## MEETING NOTICE – SITE REVIEW COMMITTEE

**Date/Time: Wednesday May 26<sup>th</sup> 2021 (5:30 P.M.)**

#### **5. DISCUSSION AND ACTION – Request for a new 1,024 square foot detached accessory building (1200 Centennial Centre Blvd., HB-2490) (Page 7)**

#### **8. DISCUSSION AND ACTION - Consider a 136 unit, 8 building leased residential development with associated site improvements (1260-1274 Lear Ln., HB-L159) (Page 32)**

N.T.S.

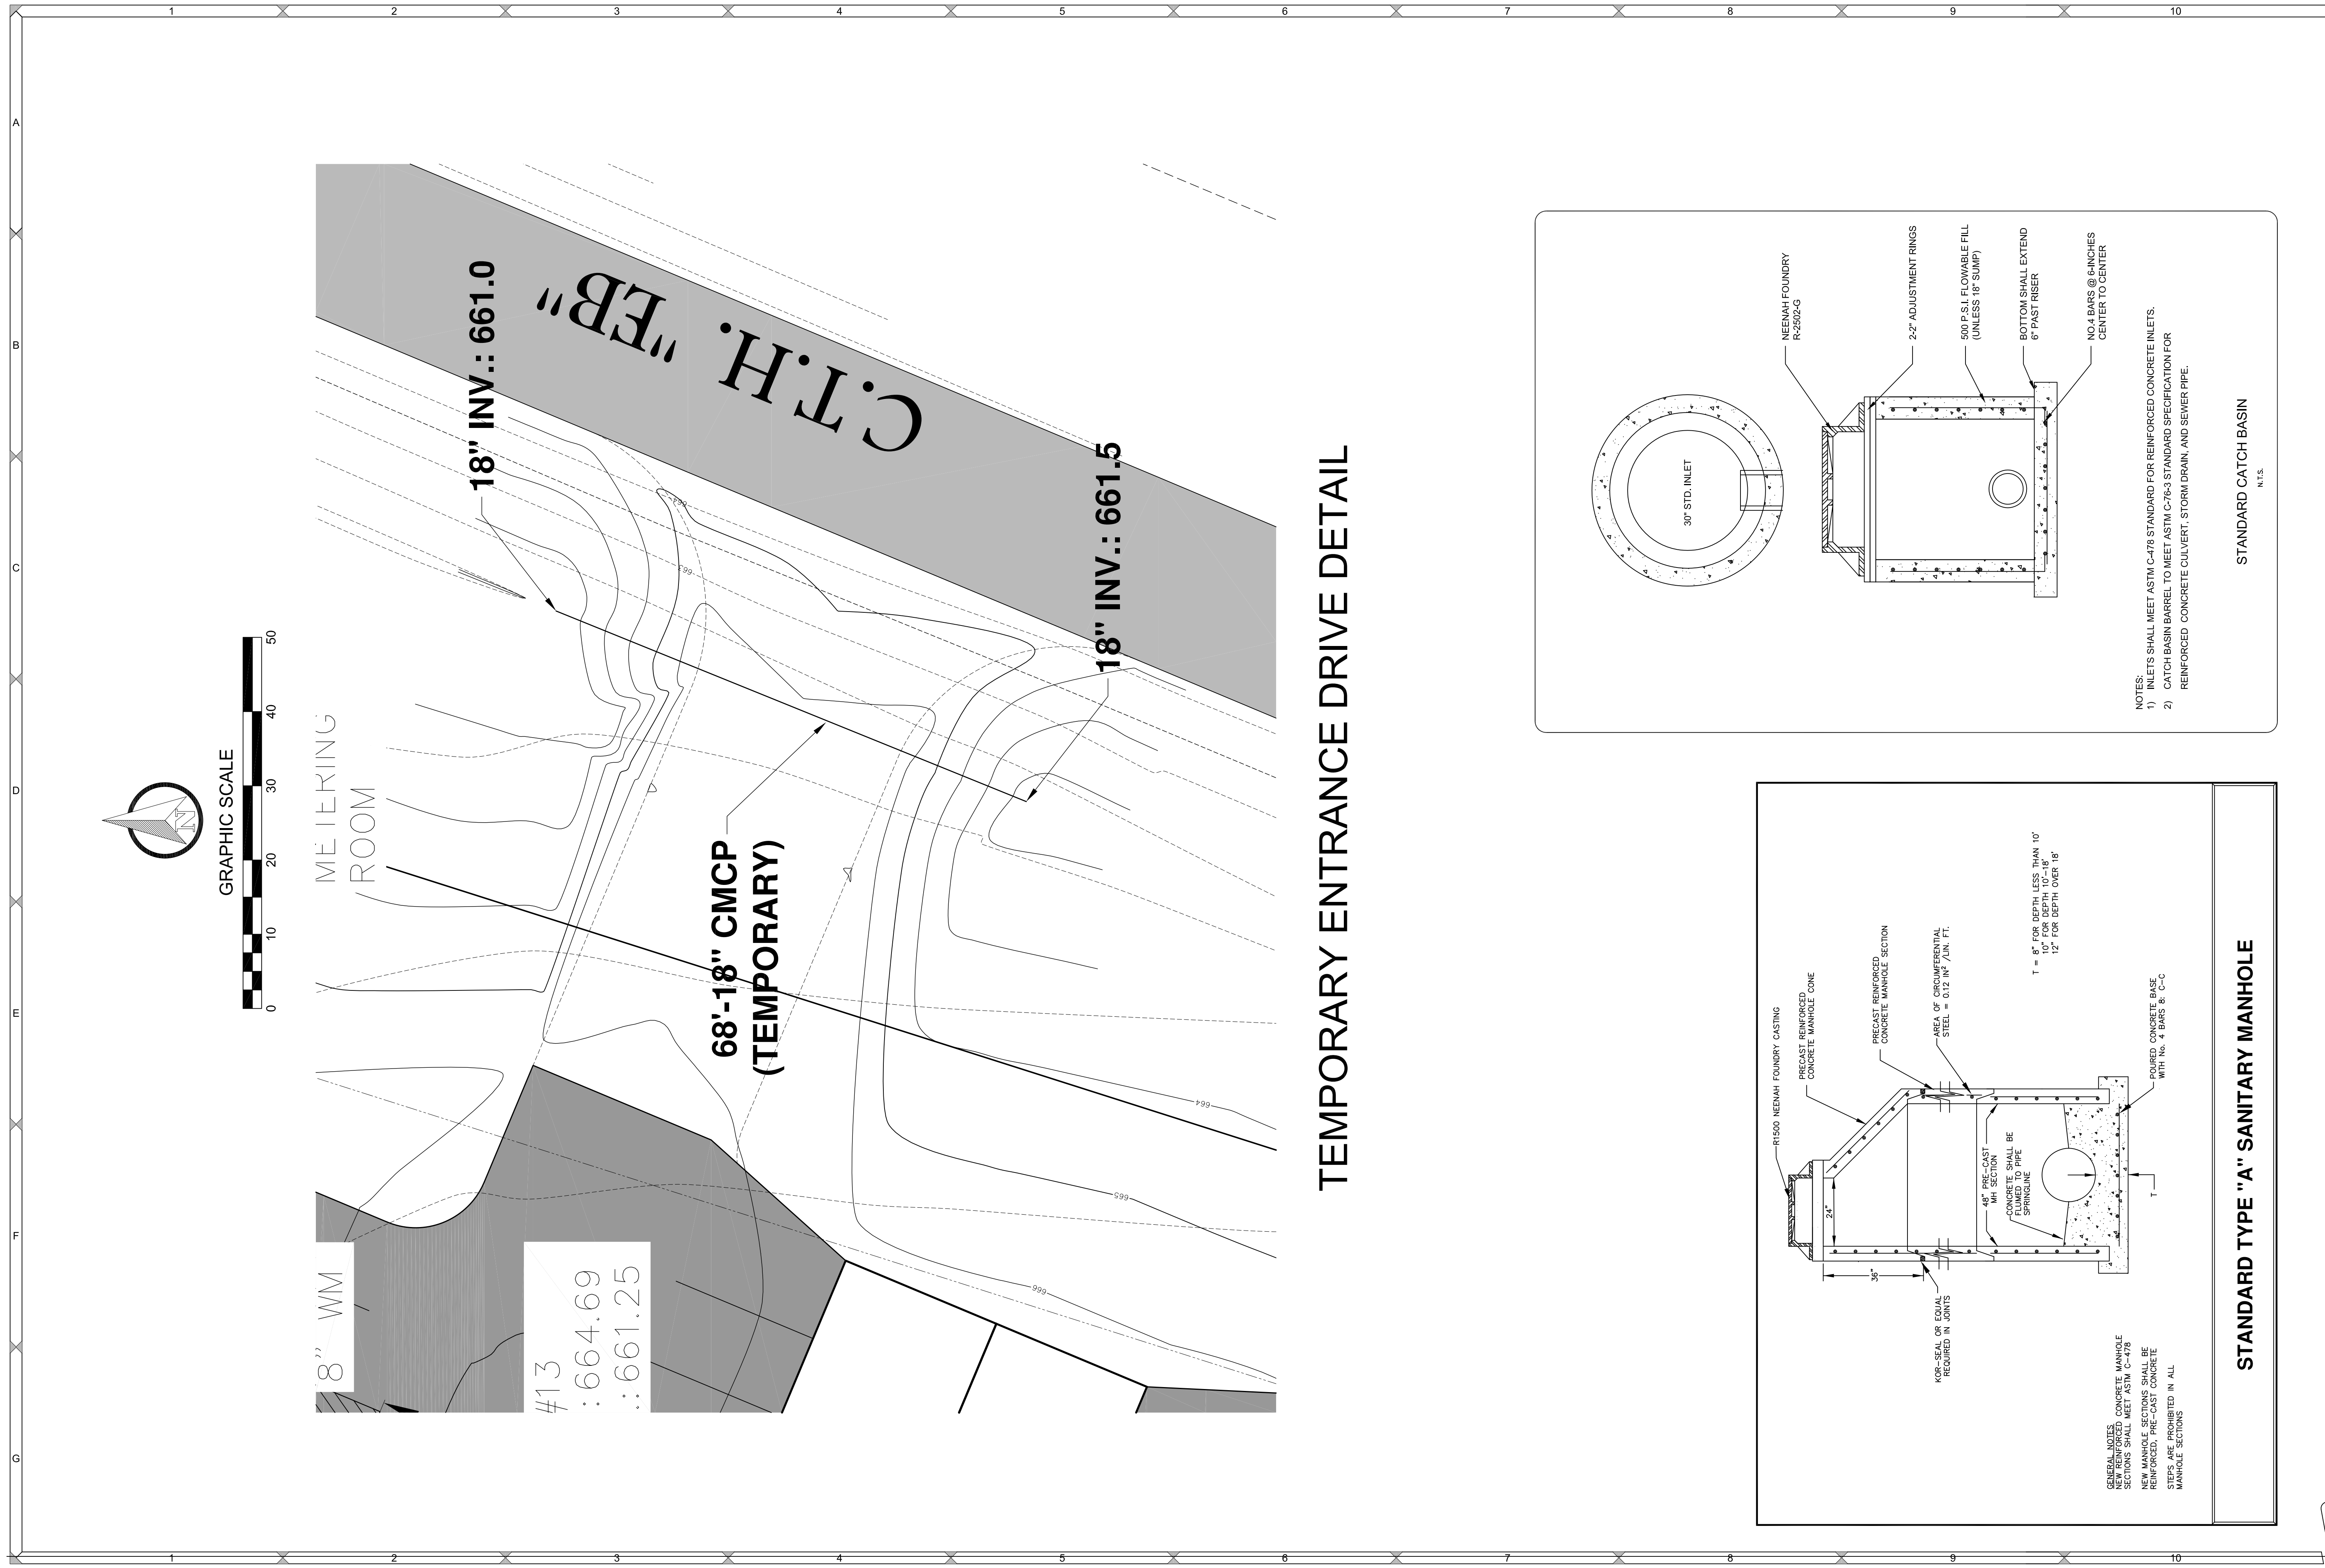
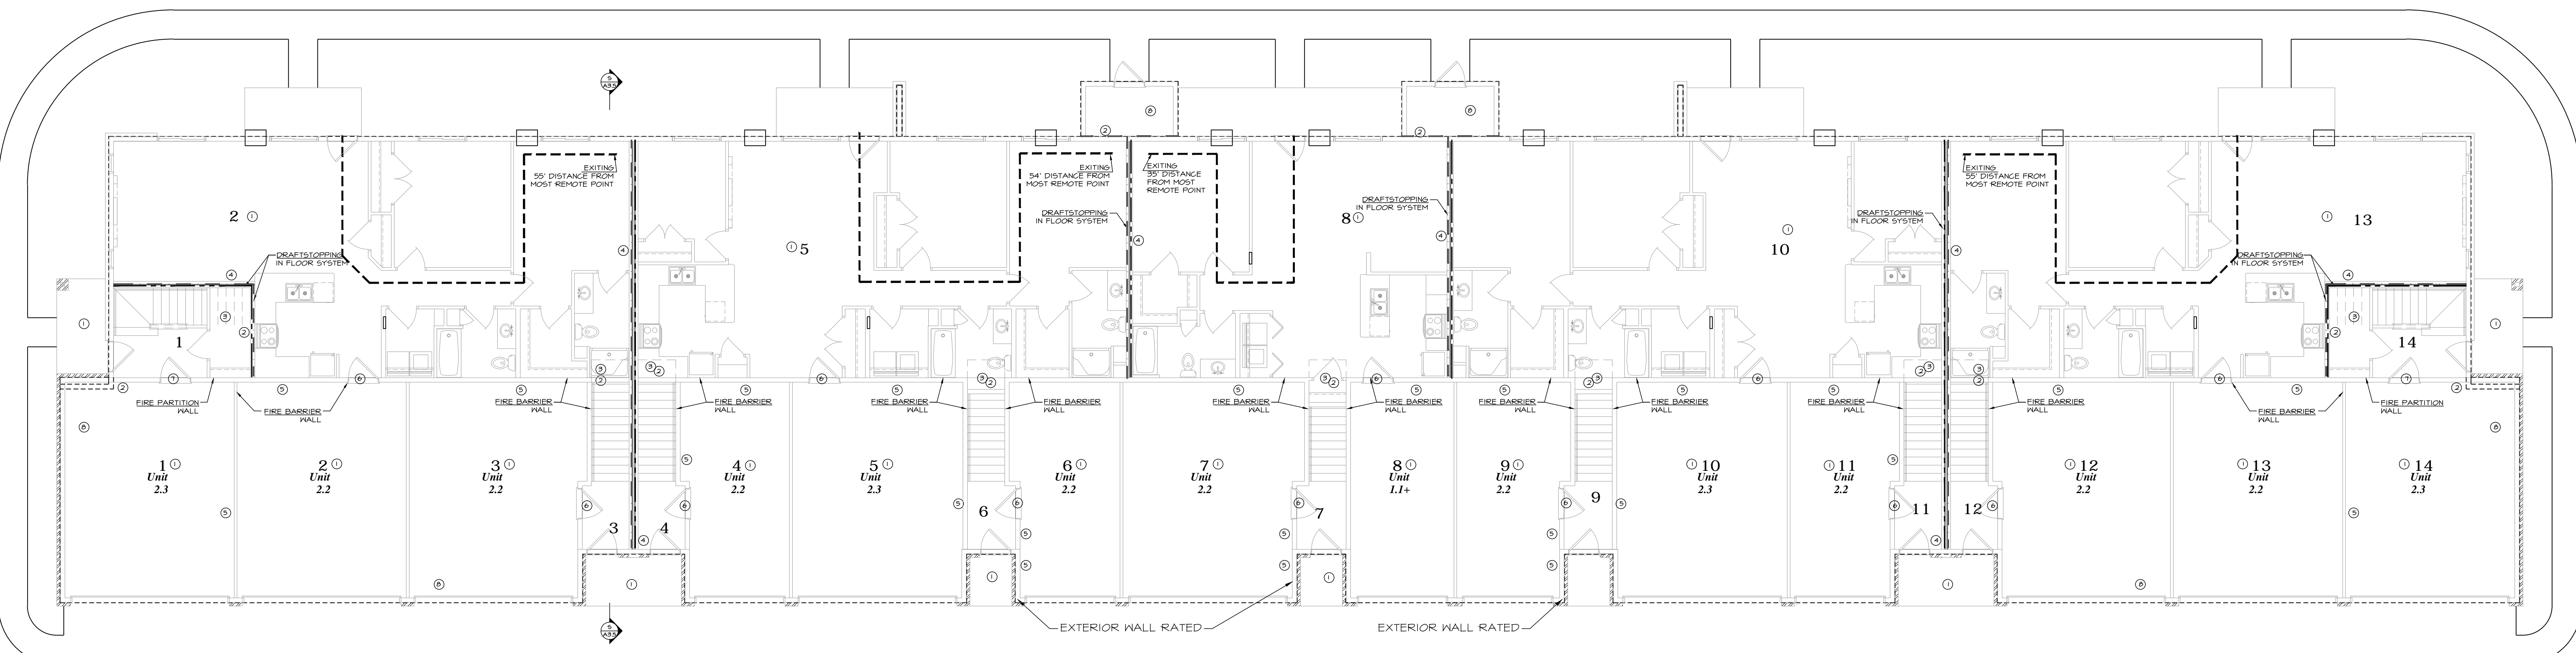
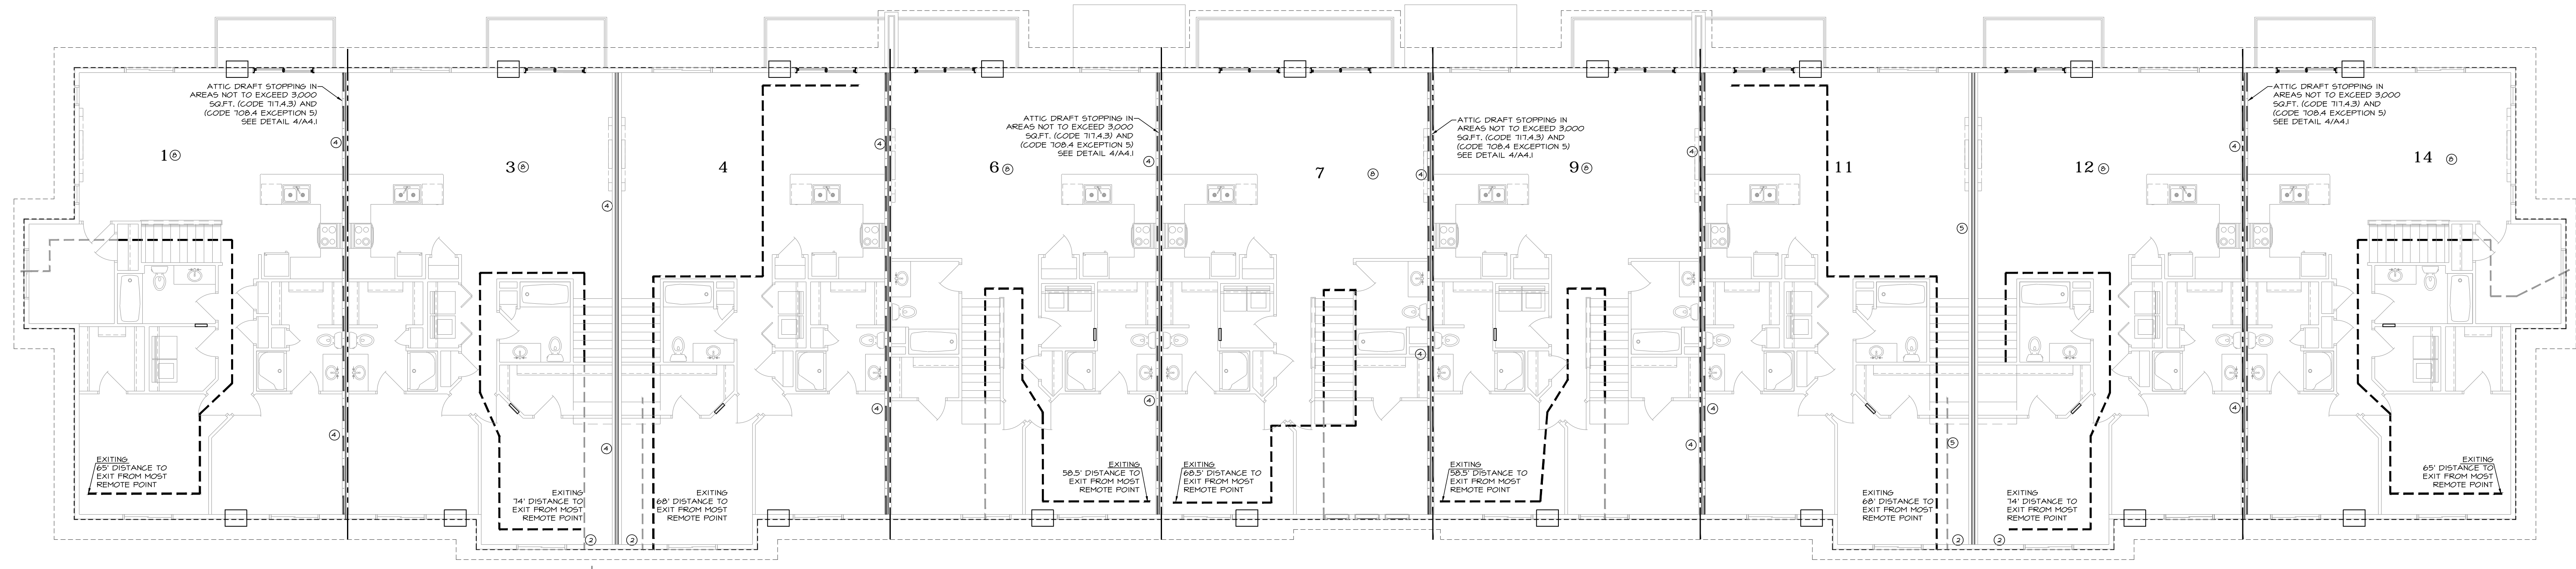
- A. Zoning:** PDD #2: Orlando/Packerland Planned Development District
- B. Green Space:** 43.5% after development
- C. Setbacks:** This development complies with all applicable setbacks (proposed 30' (front/Packerland and Lear), 59' (rear), 20' (side))
- D. Parking:** The requirements for multi-family developments are 1 stall per bedroom and 50% of the required parking must be enclosed. Staff review identified a total of 236 bedrooms. Thus 236 parking stalls are required, with 118 of those being enclosed (garage stalls.) The development provides a total of 288 parking stalls with 172 of those stalls being enclosed/garage stalls.
- E. Fire Dept. and Police Dept.:** The plans presented have been reviewed and accepted by both the Police Chief and Fire Chief with the condition that either the “temporary” access drive from Packerland Dr. remain after

- F. Storm Water:** Storm water from this phase will be collected by internal catch basins through the site and discharge to a new storm water management pond to the rear of the development then will discharge to the roadway ditch along Packerland Dr.
- G. Refuse Collection:** No additional collection area is noted on the plans, but Staff will verify prior to the meeting. They may be utilizing the existing collection area within the existing development, if large enough to accommodate the increased units.

**Section 3, Landscaping Plan:** Foundation planting proposed around both the 14-unit and 20-unit buildings with additional landscape screening between the Packerland Dr. and the 20-unit buildings. Additionally, along the west property line the 6' high white vinyl fence is proposed to be extended along with some trees to create a buffer between the multi-family development and the adjacent single-family subdivision. This fencing will extend from the existing fence in phase 1 and continue to the end of the phase 2 development.

- 1. That either the “temporary” access drive from Packerland Dr. remain after the development is completed and be constructed as a second permanent, code complying access drive into this phase of the entire complex, or another viable access point to the rear of this 2<sup>nd</sup> phase that is approved by the Village Fire Chief and Village Police Chief.
- 2. Installation of directional address signage within the proposed and existing developments working with Village Departments to verify most functional locations.
